**Environmental
Planning
Commission**

**Agenda Number: 04
Project Number: 1000936
Case #s: 16EPC-40065, 16EPC-40051 & 40052
December 08, 2016**

Staff Report

Agent	Scott Anderson
Applicant	Danny Brandenburg
Requests	<p>1) Zone Map Amendment 2) Site Development Plan for Building Permit 3) Site Development Plan for Subdivision Amendment</p>
Legal Description	Tract 4, Paradise Plaza
Location	On Unser Blvd. NW, between McMahon Blvd. NW and the Sandoval County Line
Size	Approximately 1.9 acres
Existing Zoning	SU-1 for Mixed Uses detailed in Project #1000936
Proposed Zoning	SU-1 for Mixed Use Development-C-1 Permissive Uses, excluding drive-up facilities including package liquor sales ancillary to a retail grocery of 20,000 square feet minimum and restaurant with alcoholic drink sales for on-premise consumption (maximum 4.5 acres)

SITE PLAN FOR BUILDING PERMIT

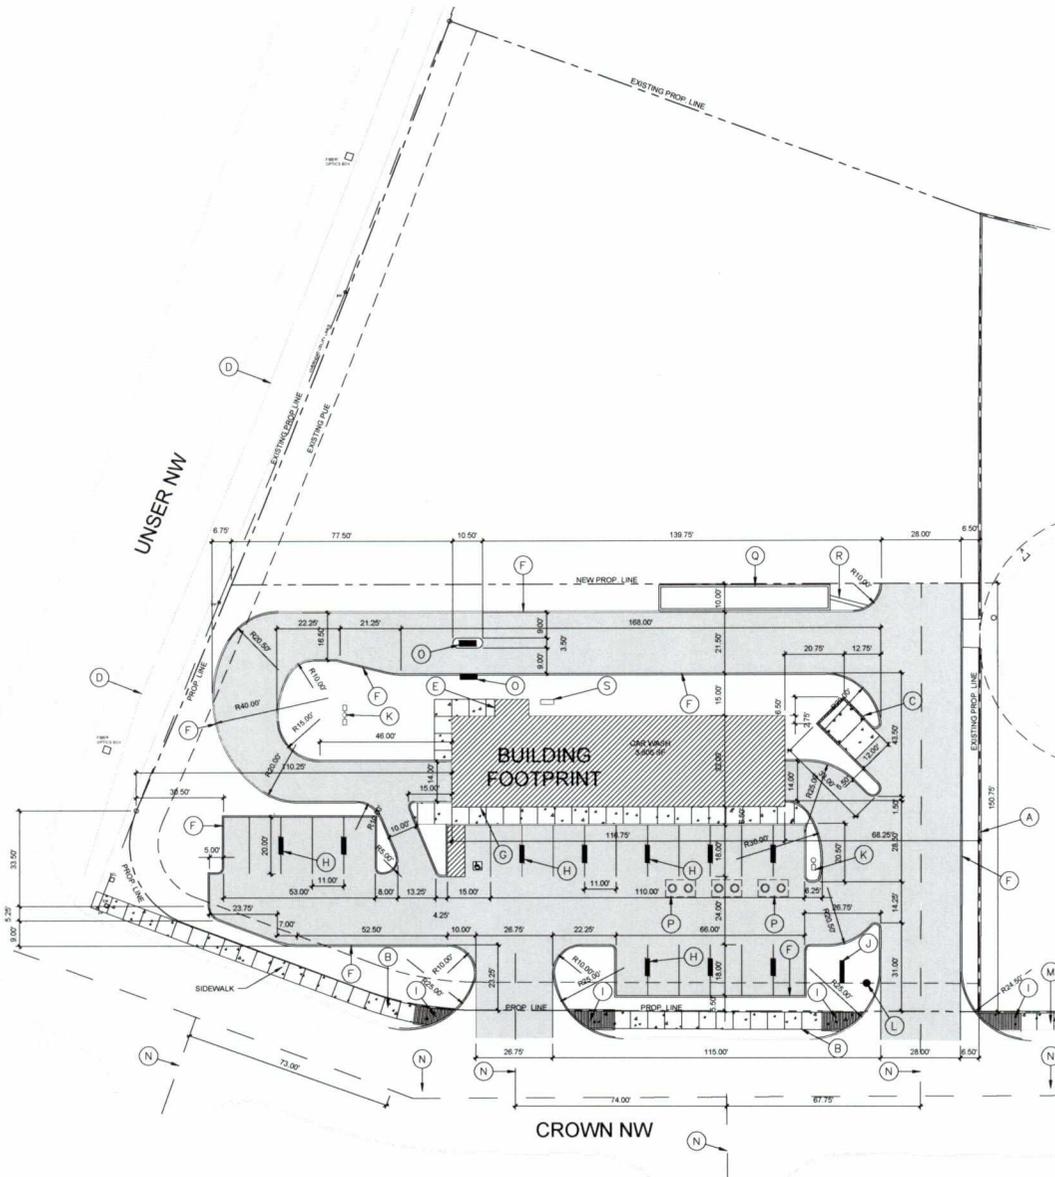
The building needs to be dimensioned horizontally. Staff gets 117 feet. Zoning Code 14-16-3-18, General Building & Site Design Regulations for Non-Residential Uses, requires outdoor seating for major façades over 100 feet. A bench is required along one of the major facades (the southern would be better). Seating calculations and a bench detail are needed.

The color(s) for the dumpster walls and gates need to be specified, and a face-on detail of the wall provided to ensure compatibility with the site (neutral color stucco, for example) as required by the design standards.

Two new light poles are proposed, both 16 feet tall. A standard light pole detail, showing fixtures and indicating height, material, and color, is needed. The light pole near the subject site's western side would conflict with the location of trees shown on the landscaping plan; adjustment of either or both is needed.

Pedestrian scale lighting is required (Standard G.6) and will need to be provided in pedestrian gathering areas, such as the patio. The location should be noted and a detail provided.

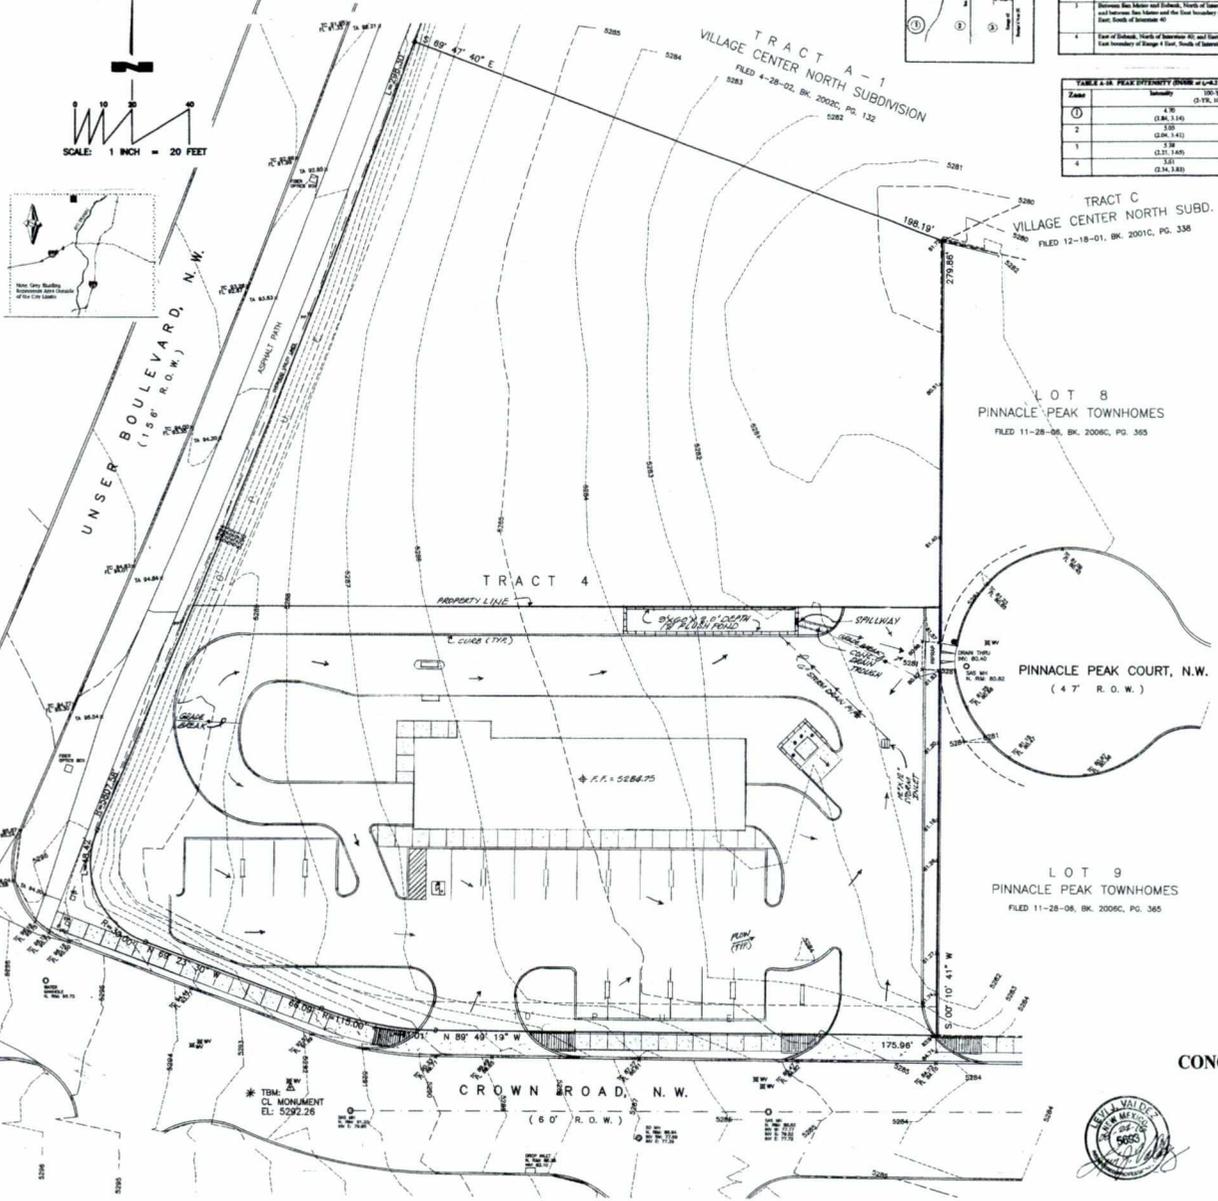
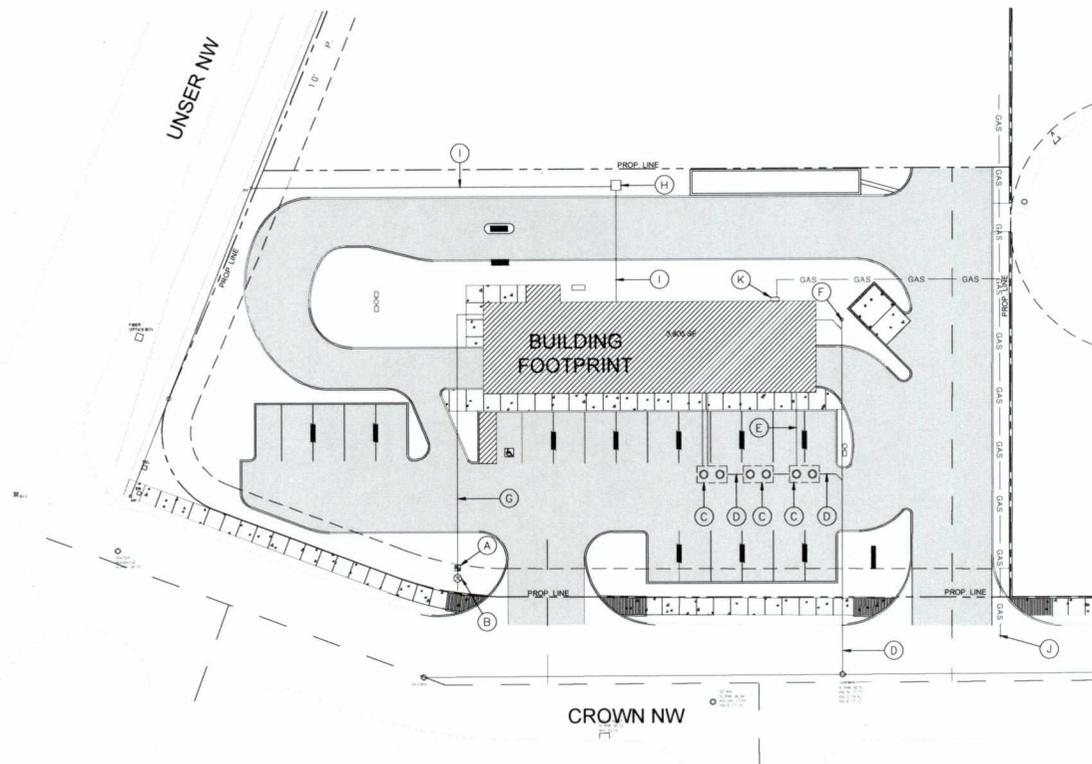
A topographic survey, rather than the standard grading and drainage plan, is provided. Water generally flows from west to east and the subject site is sunken about 5 feet from Unser Blvd. and Crown Rd.

The standard drainage narrative is absent, but should be included. The building footprint and landscaping areas need to be shown. Without them, it's not possible to show curb notches for supplemental irrigation, which are used to meet first flush requirements. Any curb notches would also need to be shown on the landscaping plan.

DRAWING TITLE		
LANDSCAPE PLAN		
DESIGNED	PROJECT NO.	L-1
DRAWN	SCALE	
CHECKED	DRAWING NO.	
REVIEWED	DATE	
DATE	DATE

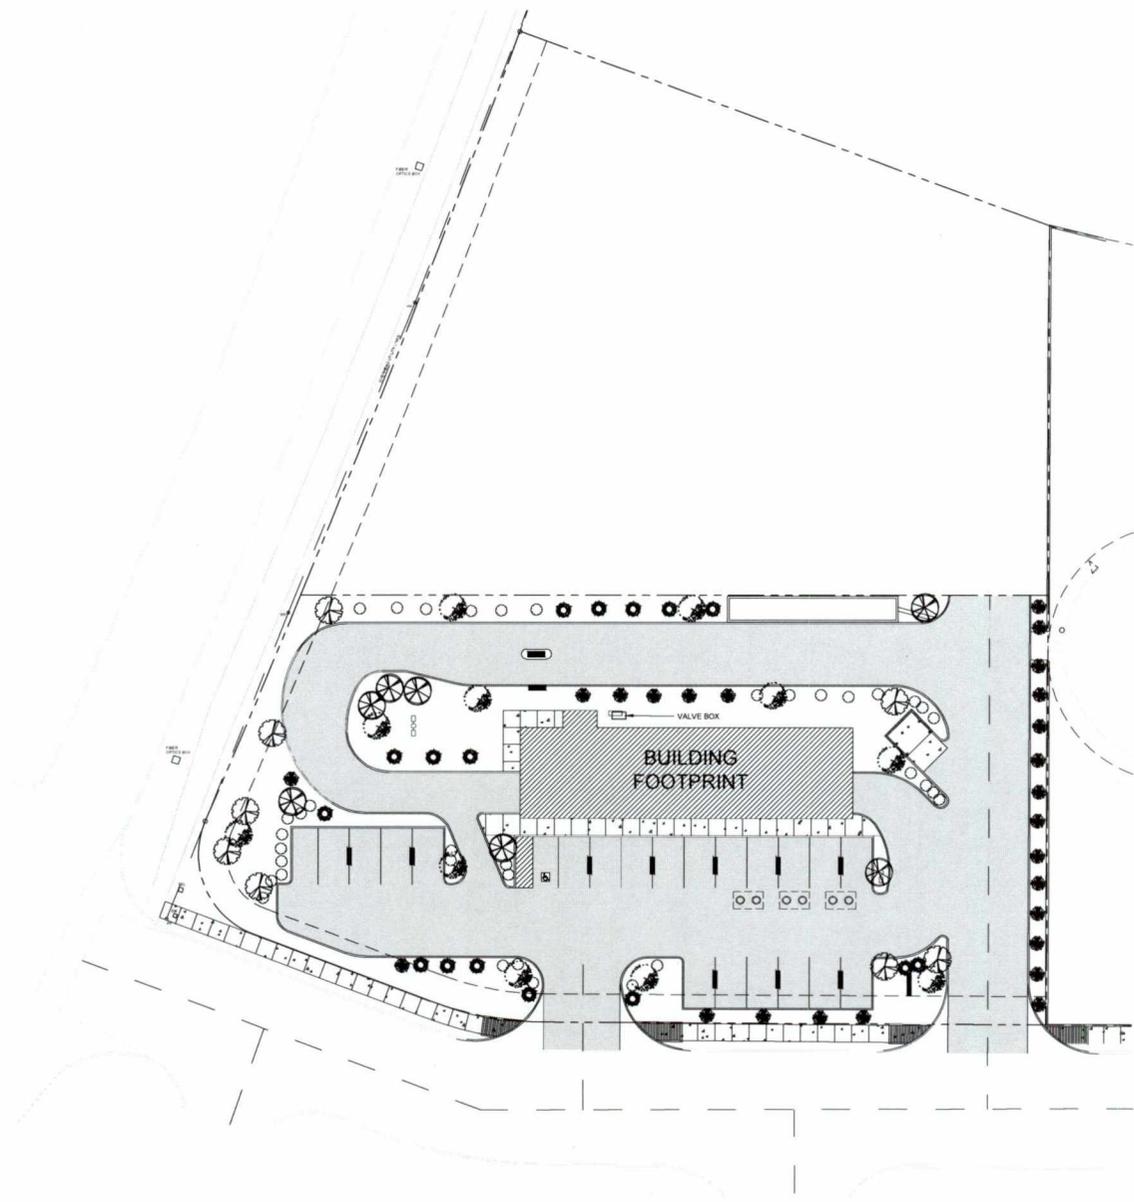
The landscaping plan proposes a variety of trees and shrubs. However, plants with a total of zero on the legend (or not being used on the landscaping plan) need to be removed. The three trees proposed (Quaking Aspen, Arizona Ash and Bradford Pear) should be replaced. Quaking Aspen requires high amounts of water and an elevation over 6500 feet (see Best Plants for New Mexico, by Baker Morrow). Arizona Ash and Bradford Pear are over used and take medium plus amounts of water. Water requirements should be listed on the legend. Staff suggests trees such as Chinese Pistache, Purple Robe Locust, and Afghan Pine.

Trees are placed where they will eventually conflict with one of the light poles and with the monument sign. Re-design is needed. The design standards require at least a 10 foot buffer between a change in uses; the 6 foot buffer shown is insufficient.

Curb notches for supplemental irrigation need to be shown on the landscaping plan, and be in the same locations as on the grading and drainage plan. Underground irrigation is required by the design standards; however, the irrigation detail shows a pop-up bubbler.
